209024

INDEPENDENT MONITOR AUDIT OF THE ENVIRONMENTAL PERFORMANCE OF THE MCARTHUR RIVER MINE – 2008 OPERATIONAL PERIOD

ENVIRONMENTAL EARTH SCIENCES VIC
REPORT TO THE DEPARTMENT OF REGIONAL DEVELOPMENT,
PRIMARY INDUSTRY, FISHERIES AND RESOURCES

AUGUST 2009

Project: McArthur River Mine Independent Monitor		Job No: 209024
Project Man: GM	Scale: Not to Scale	Figure 2
Drawn By: LB	Date: August 2009

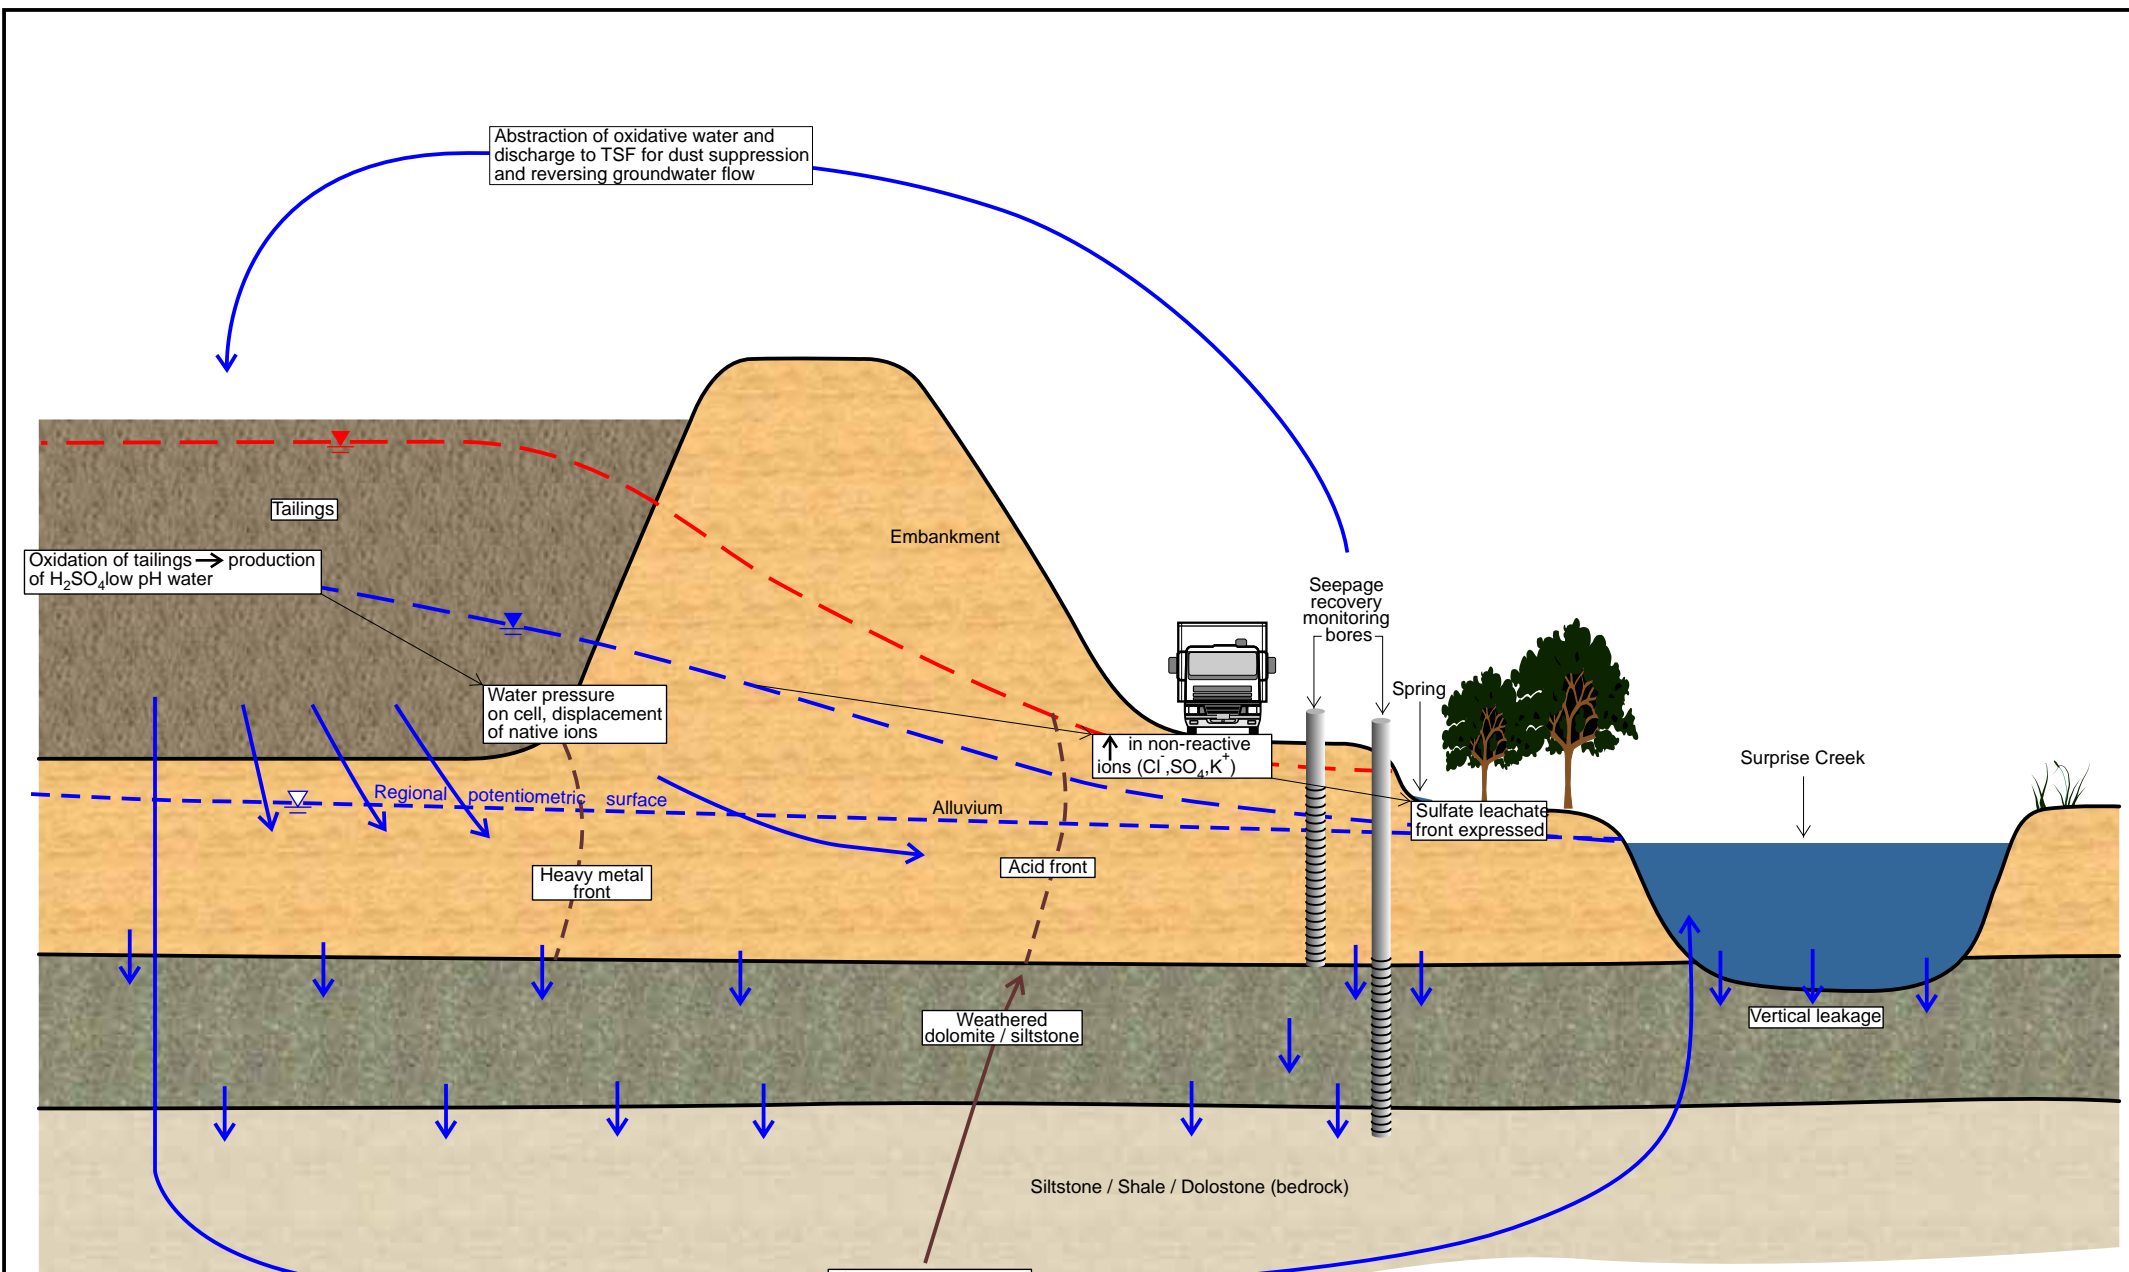
Following a review of tailings geochemistry results for the 2007-2008 period, it is apparent that more acid is being generated than predicted by the NAG test, but less acid than predicted by NAPP. When the tailings started to produce acid, the amount and rate of acid generation and the impact on the geopolymer barrier was obviously, and continues to be, unknown (this has been identified as a Category 3 Gap within the Gap Register – see Appendix D). Thus, predicting the impact on the environment and designing the necessary mitigation measures cannot be readily achieved at this time.

A preliminary conceptual geochemical model of seepage migration from the Tailings Storage Facility is presented in Figure 2, which provides the likely processes occurring.

The Independent Monitor provided detailed recommendations for further investigation into this matter within a letter *McArthur River Mine Independent Monitor – notification of investigation under Section 6.4 of the IMAC* to General Manager McArthur River Mining (cc: DRDPFR) dated 6 July 2009 (Environmental Earth Sciences, 2009).

Title: Conceptual Geochemical Classification of OEF	
	Location: McArthur River Mine Northern Territory	
Project: McArthur River Mine Independent Monitor		Job No: 209024
Project Man: GM	Scale: As shown	Figure 16
Drawn By: LB	Date: August 2009

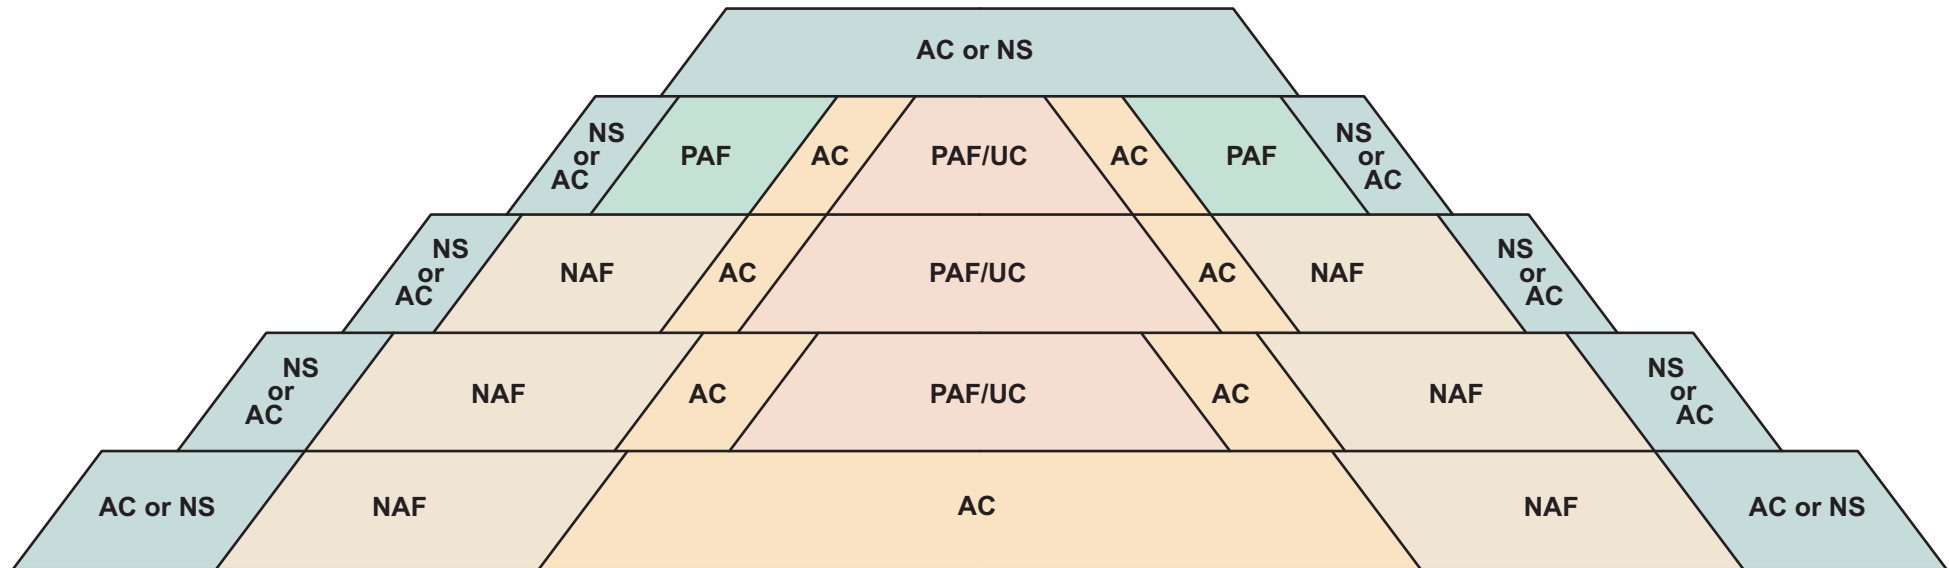
The Independent Monitor commends the mine geologists for identifying the variations in waste geochemical classifications of materials generated as these measures will improve the environmental performance of MRM. However, this also highlights the need for MRM to update their current waste rock identification, handling and storage procedures as these changes need to be formalised should changes in mine personnel occur.

In its current form, the methods employed by the mine geologists in identifying and classifying waste rock vary from the adopted plan and as such, we recommend that the conceptual design, similar to that presented in Figure 16, and design be re-evaluated in conjunction with the field weathering trials described below. Furthermore MRM's written procedures need to be updated in line with the current practices undertaken, which includes and understanding of sulfide association with structure and geology.

- larger scale field weathering trials be undertaken on selected materials that are currently classified as NAF, PAF, AC and UC to evaluate long-term leachate generation quality. As the rate of acid and/or saline leachate production, and possible change in geotechnical integrity, is function of the rock mineralogy, geochemistry and size, we consider that the results of kinetic column tests be abandoned or used in conjunction with larger scale field trials. These trials will also aid in the development of rehabilitation strategies;
